## ARLINGTON COUNTY, VIRGINIA

**County Board Agenda Item  
Meeting of December 9, 2006**

**SUBJECT:** Adoption of the 2006 Clarendon Sector Plan – Part 2 and updates to Part 1

### **SUPPLEMENTAL REPORT** **Additional Information and Revised Drawings**

# OPTION 1 (Revised 12/07/06)

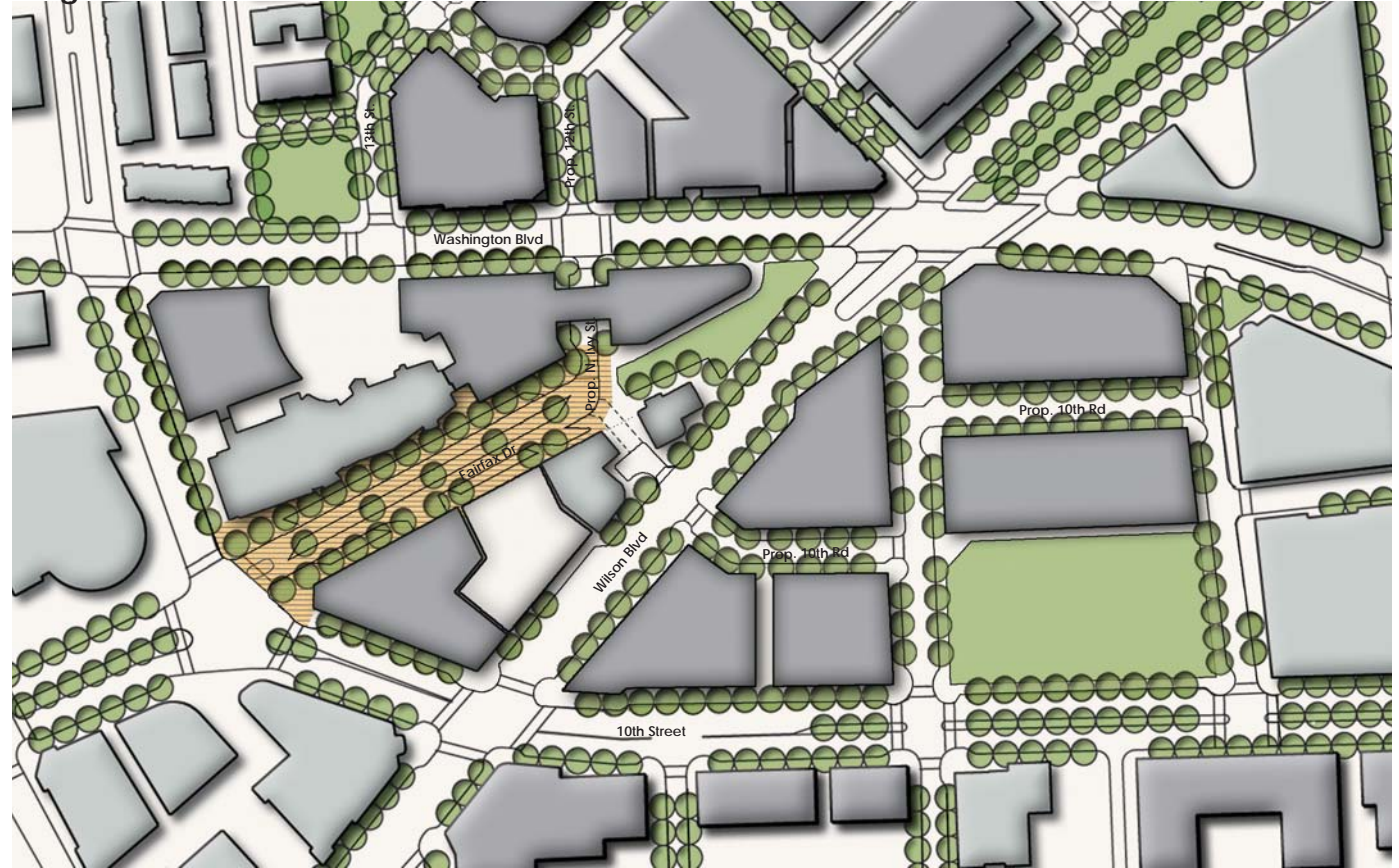
- N. Ivy St. segment between Kirby Garage and Murky Coffee buildings:
  - designated for pedestrians, bicyclists, and service access;
  - defer determination of space for through-traffic until a future time when adaptive reuse of buildings are clarified and expansion of building is determined
  - space designed with removable bollards that limit regular through-traffic but could be removed to permit a through connection in emergency conditions
  - width of proposed street segment would allow for 1 travel lane plus 2 sidewalks with landscaping
- Proposed street alignments and open space locations and configurations retain flexibility for adjacent redevelopment sites including:
  - Limits impacts to St. Charles Church property by connecting N. Ivy Street with 12<sup>th</sup> Street and would not require the removal of an

This option, as shown, has been used to update the maps and text in the sector plan. If another alternative is selected, adjustments to the sector plan would be necessary.

# OPTION 1 (Revised 12/07/06)

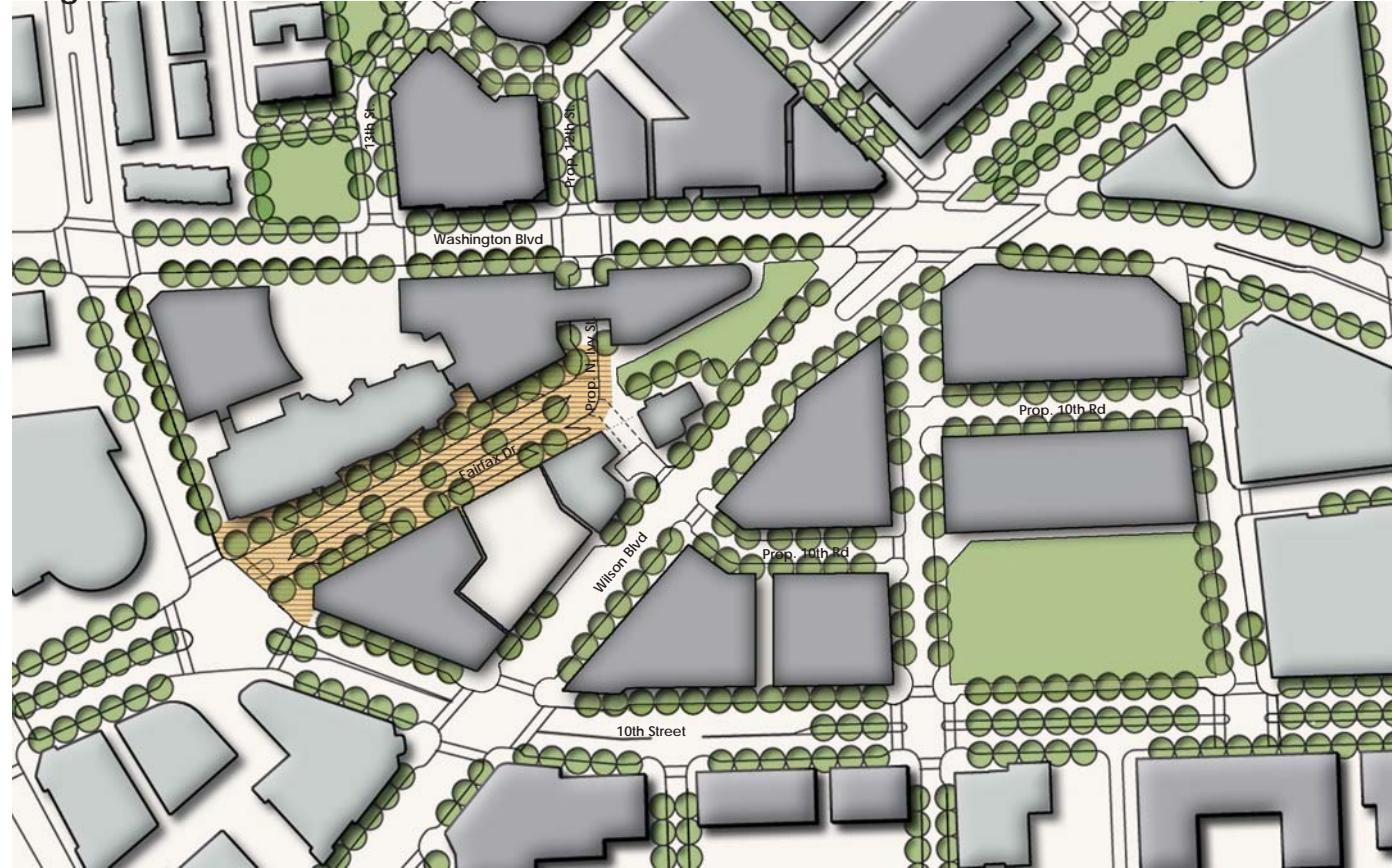
**DISCUSSION:** After further internal discussion, staff has clarified the recommended concept for Fairfax Drive and prepared a revised concept plan for Option 1 (see attached). The changes to Option 1 are limited to Fairfax Drive, from 10<sup>th</sup> Street to the proposed North Ivy Street; no additional changes to Option 1 are proposed.

This option, as shown, has been used to update the maps and text in the sector plan. If another alternative is selected, adjustments to the sector plan would be necessary.
